SUBJECT: Staff Analysis of the PG&E Petition to Eliminate the Use of San Joaquin River Water as the Cooling Water Source and Complete Ten Associated Project Design Changes at the Gateway Generating Station (00-AFC-1C)

**Gateway Generating Station Project
(00-AFC-1C)**

**Petition to Eliminate the Use of San Joaquin River
Water as the Cooling Water Source and Complete
Ten Associated Project Design Changes**

Staff Analysis

VISUAL RESOURCES - FIGURE 2

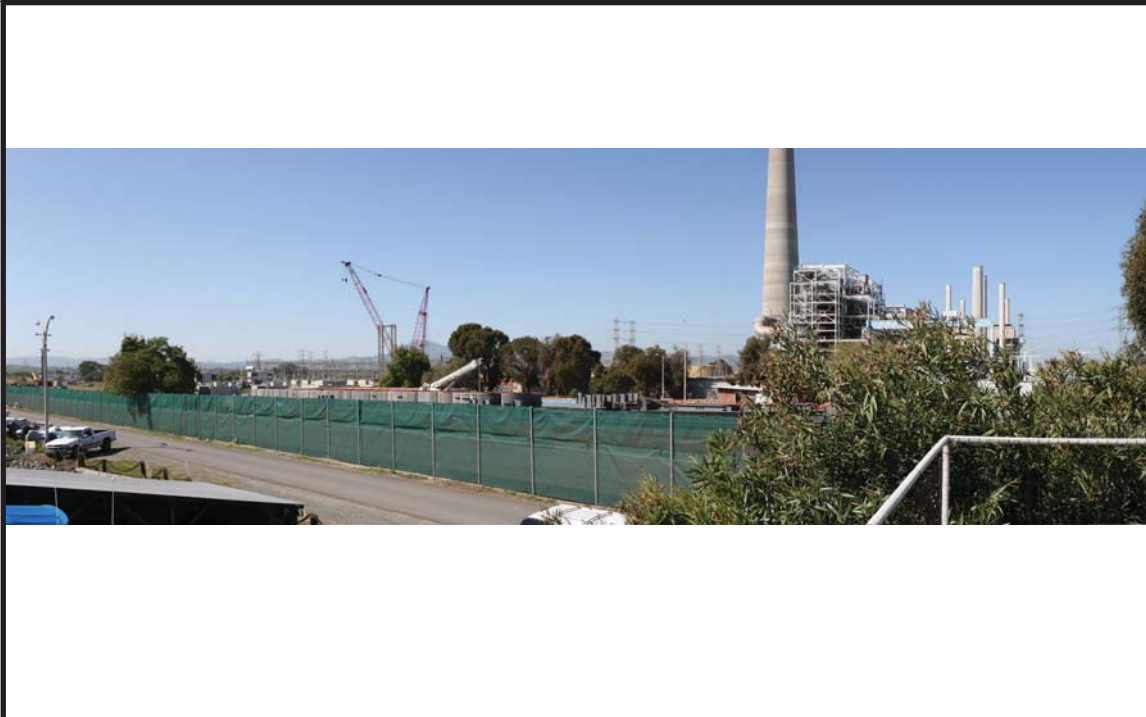
The top photo of **VISUAL RESOURCES Figure 2** shows a simulation of the approved project as seen from KOP 2. In this simulation, the HRSGs and stacks as well as the cooling towers are visible from this vantage point. The cooling towers are located just below the Antioch Bridge, and just above the existing tree line. In the original application, Commission staff determined that although this is an open view, the majority of the view is typically obstructed by extensive existing industrial structures, thereby lowering the visual quality to a moderate level. The visual impact of plumes was also not considered critical, as views of the project from the two cemeteries and Almond Ridge Park would be completely filtered by intervening trees and structures.

The bottom photo of **VISUAL RESOURCES Figure 2** shows the ACC structure and reflects its appearance as prominent, although the base of the structure is partially screened by existing mature vegetation situated to the south of the site. The ACC unit would obstruct a portion of the Antioch Bridge, however a substantial portion of the bridge structure would remain visible from KOP 2. Similar to the discussion at KOP 1, the ACC unit would provide an additional structure in a view that includes a variety of large-scale industrial structures (i.e., transmission towers, existing power plant and stacks). The overall visual effect of the ACC unit would be relatively minor and result in an incremental change to existing visual conditions with the beneficial effect of eliminating visible plumes.
